FINAL ENVIRONMENTAL IMPACT REPORT

Washington Square Mixed-Use Development

ENV-2007-5046-EIR

Figure 1
Site Access - Option A

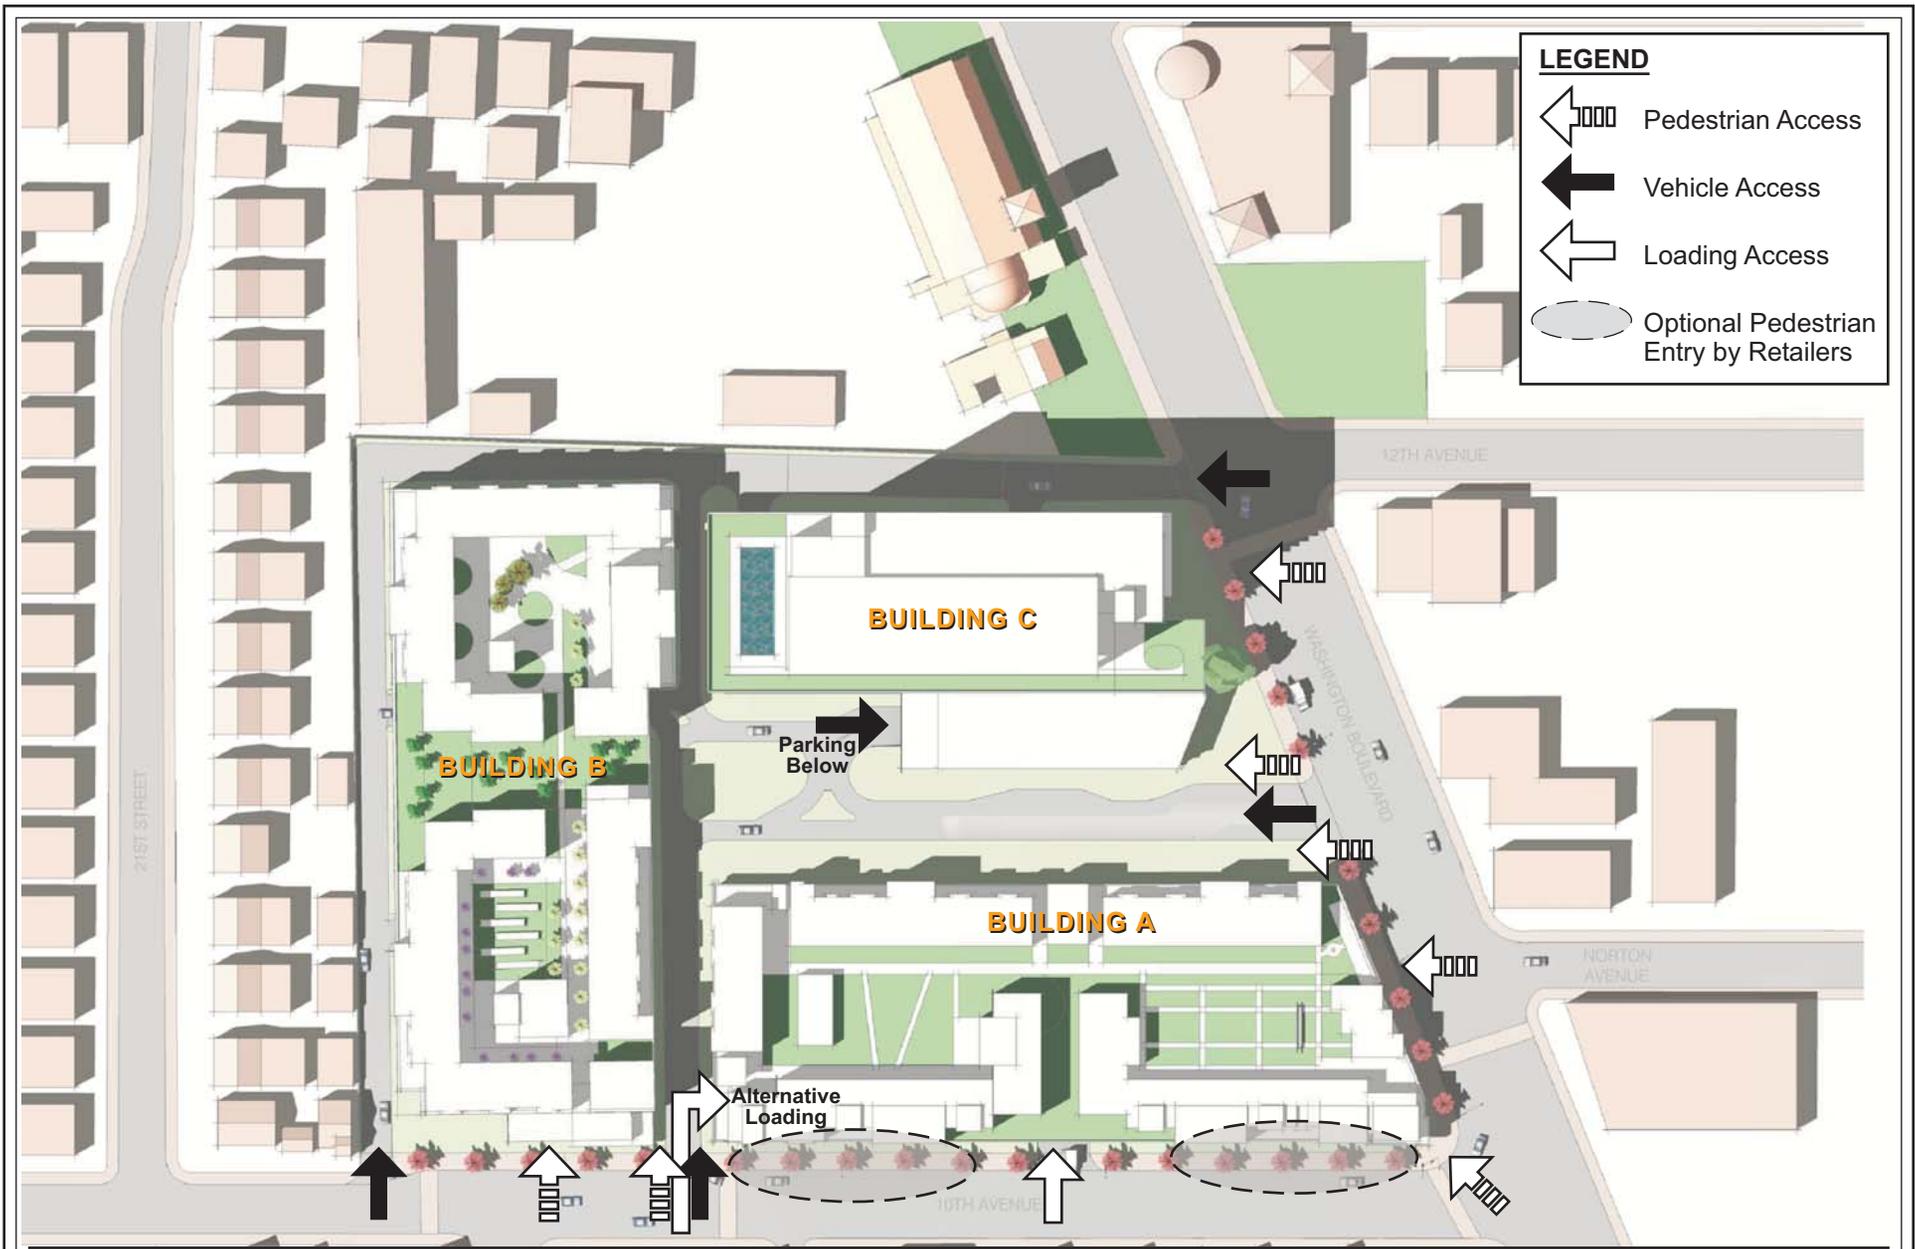
1) Despite the claims in the DEIR that the project is pedestrian oriented and pedestrian friendly, the reality is the opposite. The primary entries and plazas to the project are automobile oriented. Though pedestrian circulation may be accommodated within the project, there is no effort to engage the project with the pedestrian realm of the street.

Figure 3, *North and East Elevations - Option A*, on page III-43, and Figure 4, *North and East Elevations - Option B*, on page III-44, in this Final EIR, illustrate the building facades as viewed from Washington Boulevard (North Elevation) and 10th Avenue (East Elevation) under both project options. As can be seen in these figures, the project (Option A and Option B) would not locate blank walls along the streets. Figure 5, *South and West Elevations - Option A*, on page III-45, and Figure 6, *South and West Elevations - Option B*, on page III-46, in this Final EIR, illustrate the views of the Options A and B from St. Paul's Catholic Church to the west and from the residential uses to the south. Figure 7, *Existing and Computer Rendered Views from 10th Avenue*, on page III-47, illustrates the existing view along 10th Avenue and the view as it would appear with the proposed development. Figure 8, *Existing and Computer Rendered Views from the corner of Washington Boulevard and 10th Avenue*, on page III-48, illustrates the existing view of the project site from this corner and as it would appear with the proposed development. Figure 9, *Existing and Computer Rendered Views from Washington Boulevard - Option A*, on page III-49 and Figure 10, *Existing and Computer Rendered Views from Washington Boulevard - Option B*, on page III-50, illustrate the existing view of the project site from this street and as the street front would appear under each project option. As shown in these drawings and photo simulations, the street facing walls would be detailed with landscaping, architectural articulation, and vehicle and pedestrian entrances. Therefore, no further mitigation as suggested in sub-item "a," is necessary.

The project's only two-story garage is located in the south half of Building B (Option A) and Building 2 (Option B). The north section of this building would contain a commercial use (possible community meeting room) that would be directly accessed from the 10th Avenue sidewalk. In addition the north edge of this building would consist of commercial uses that are directly accessed at grade from the 10th Avenue entrance to the project. As shown in Figure 3, the residential uses along 10th Avenue would be oriented to the public street. However, the lower stories of these mixed-use buildings would be occupied by commercial uses. The project would provide interior open space and an interior driveway for onsite residential uses and, as such, primary access from the sidewalk to the upper story residential uses is not a design feature of the project given the interior orientation of the open space, driveway, and residential parking. However, as shown in Figures 1 and 2, Option A and Option B would provide several access points at which onsite residents would access public sidewalks and connect with the surrounding community. Therefore, no further mitigation as suggested in sub-item "b," is necessary.

As discussed in Response to Comment No. 6-3, Figure 1, *Site Access - Option A*, and Figure 2, *Site Access - Option B*, illustrate the proposed pedestrian access points. As shown in Figures 1 and 2, direct access to the development would be available at four points along Washington Boulevard and at two points along 10th Avenue under Option A. Option B would provide two direct access points on Washington Boulevard and two points along 10th Avenue. Also as shown in these figures, retailers along Washington Boulevard and 10th Avenue would have the option to provide street-oriented entrances along the majority of the street frontages.

Figure 3
North and East Elevations - Option A

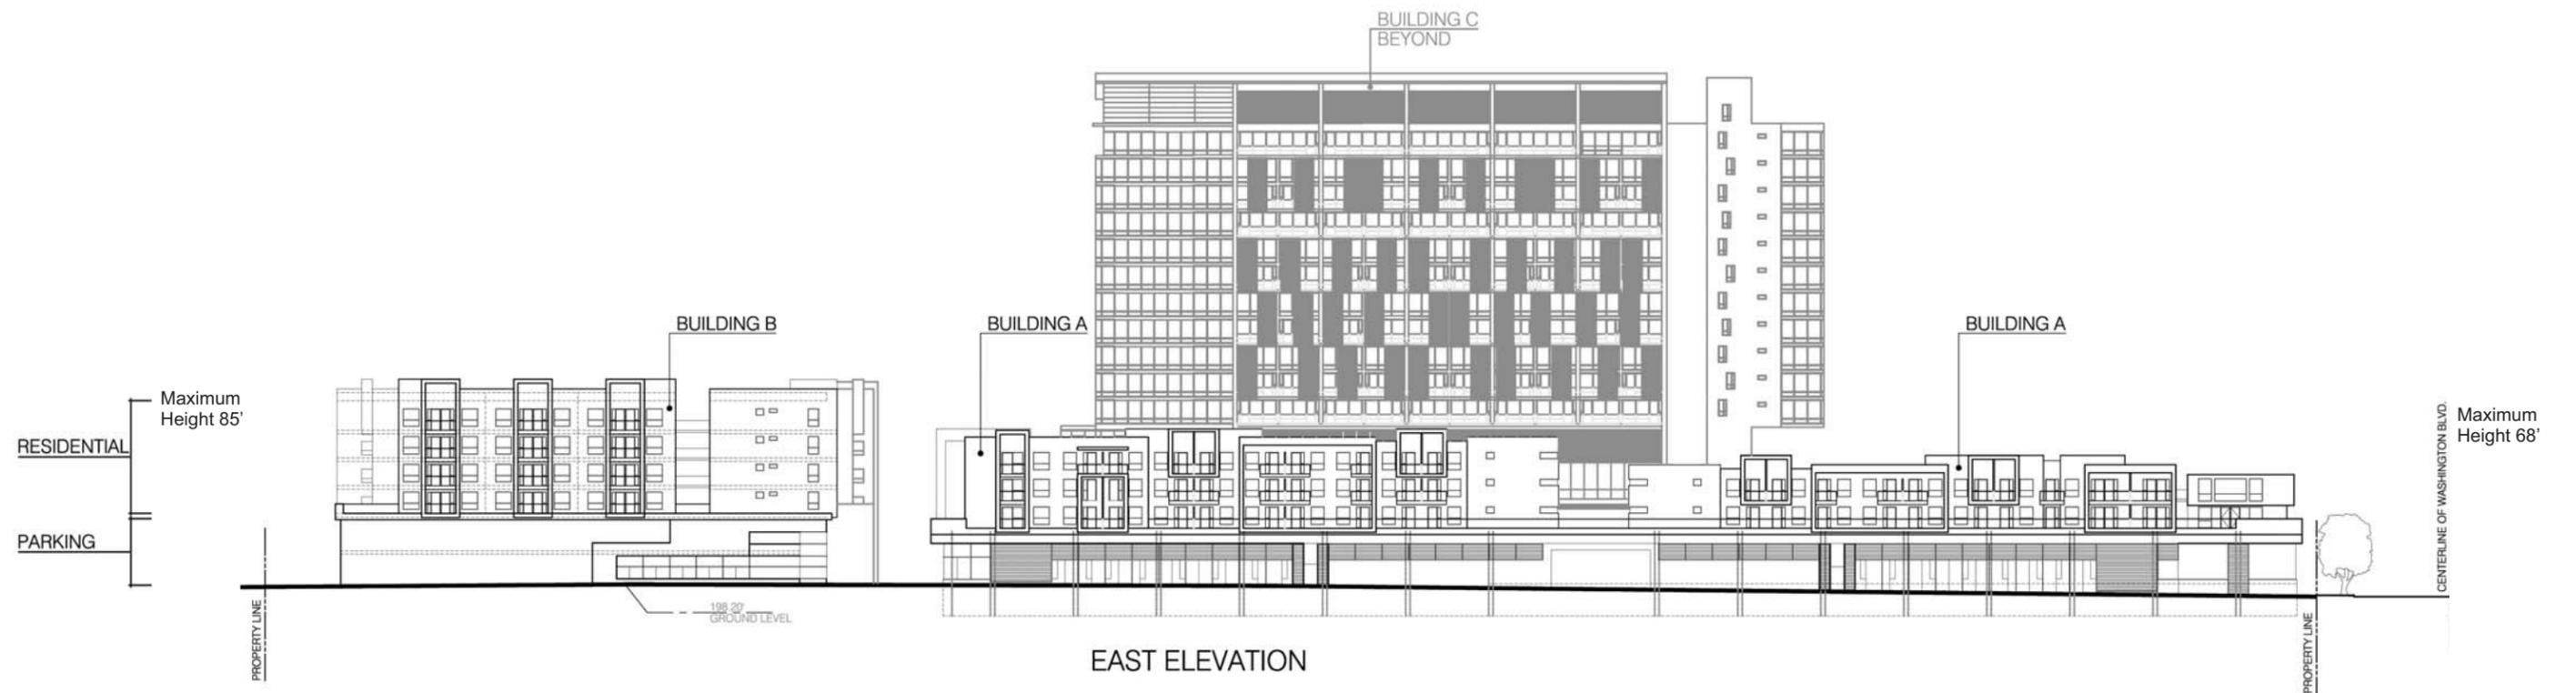
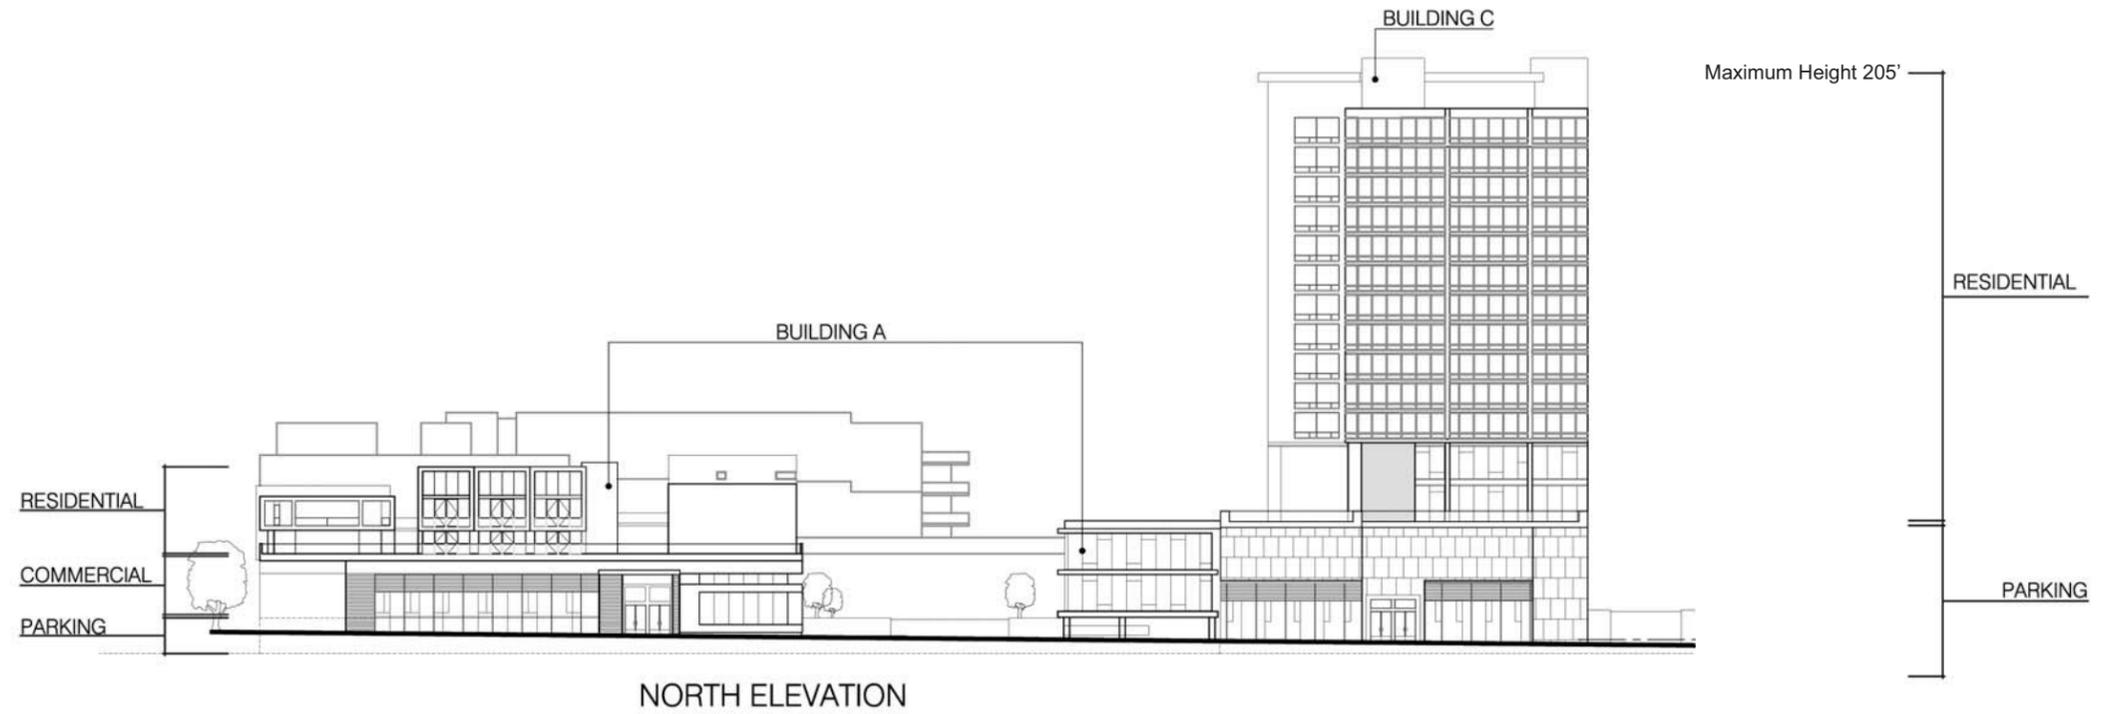
2) The project places two-story garages above grade along most of the property line frontages. This creates a fortress-like quality to the project that disengages the project from the surrounding context and creates an inward-looking, architecturally fearful attitude for the project. Creating a walled compound in the middle of a vital urban neighborhood is not only a regressive

An illustration of the west façade of Option A is provided in Figure 5 of this Final EIR. Compared to the east façade, as shown in Figure 3, which was also provided in Response to Comment No. 6-3, the two façades are considerably different, due to the location of the proposed 18-story tower deeper in the background of the east elevation (see Figure 3). These elevations do not provide additional information that would alter the analysis contained in the Draft EIR. Rather, these figures provide substantiation of the conclusions reached in the Draft EIR.

Figure 11
Washington Square Redevelopment
General Stacking Diagram

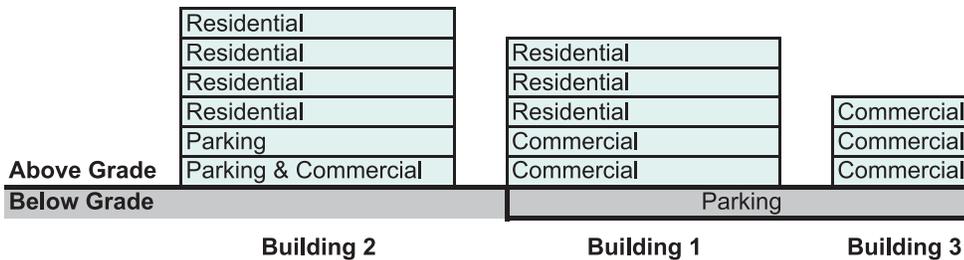
COMMENT NO. 6-5

- 1: The above diagram is provided generally illustrate the overall stacking of the building uses in relation to the overall existing grade. This diagram shall not be used to determine the relative sizes/heights of the buildings or their elevations relative to grade.

Figure 12
Site Plan - Option A

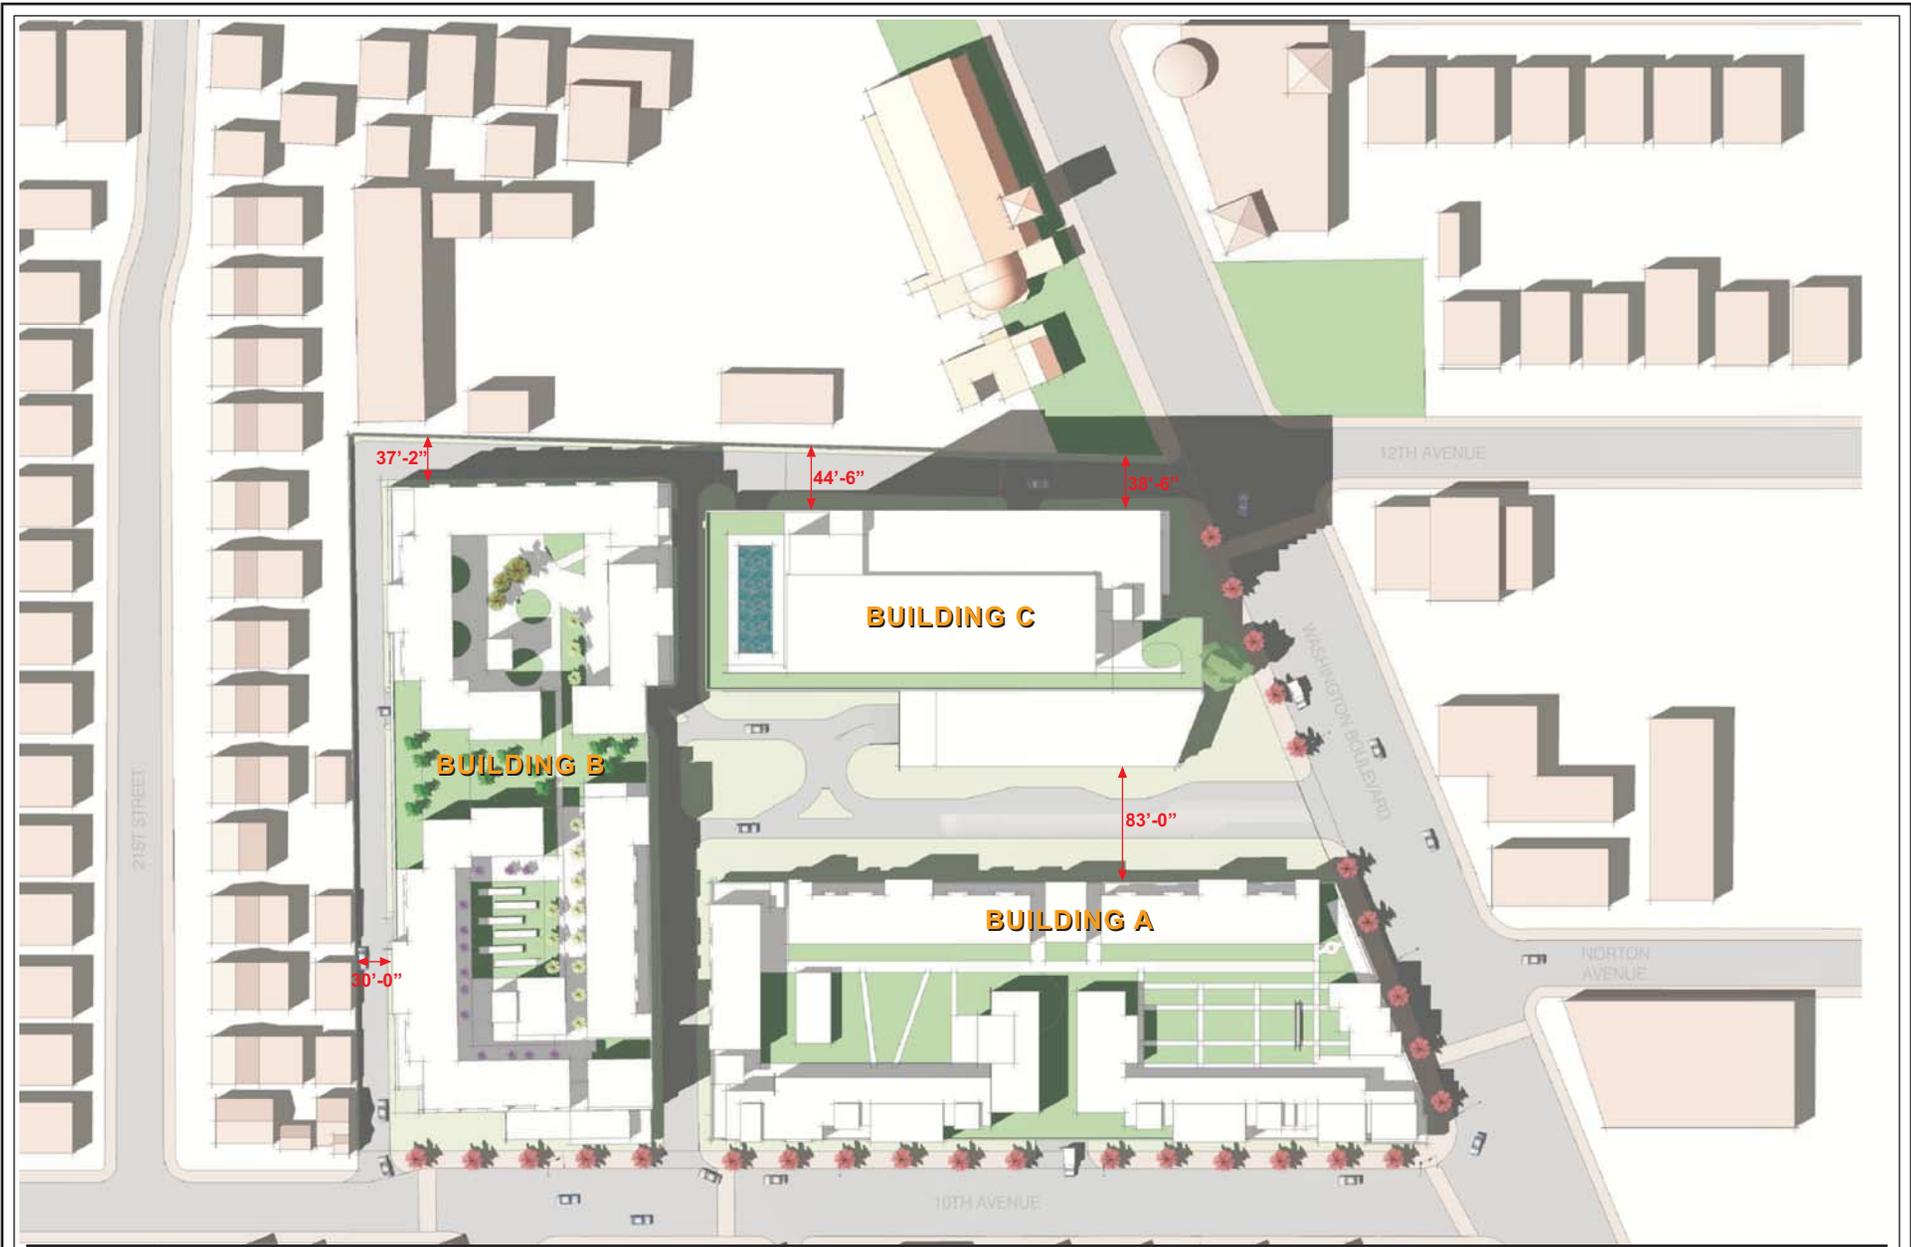
We agree in principle that use of the Washington Square site for a mixed-use community center combining retail and residential space would be consistent with applicable City of Los Angeles plans, goals, policies, and guidelines (hereafter “policies” is used to refer to all of these), and that a mixed-use project could be implemented on this site without significant impacts. We do not agree, however, that either of the specific projects evaluated by the DEIR is consistent with the policies applicable to contextual appropriateness, or pedestrian orientation; or that, if implemented, the only significant impact would arise from the relationship of the tower in Option A to the church.

The site plans provided in Figure 12, *Site Plan - Option A* and Figure 13, *Site Plan - Option B*, in this Final EIR, illustrate the context of the project compared to the surrounding uses. The elevations provided in Figures 14 through 21, of this Final EIR, depict the street-view elevations of the project and adjacent uses from all four cardinal directions (north, east, south, and west) for Option A and Option B. These illustrate the scale of the project with respect to adjacent and surrounding uses. This additional information provides more detail regarding pedestrian access and the relationship of the project to surrounding uses. These figures support the conclusions reached in the Draft EIR regarding compatibility of scale, and pedestrian orientation. Please see Response to Comment No. 8-2.
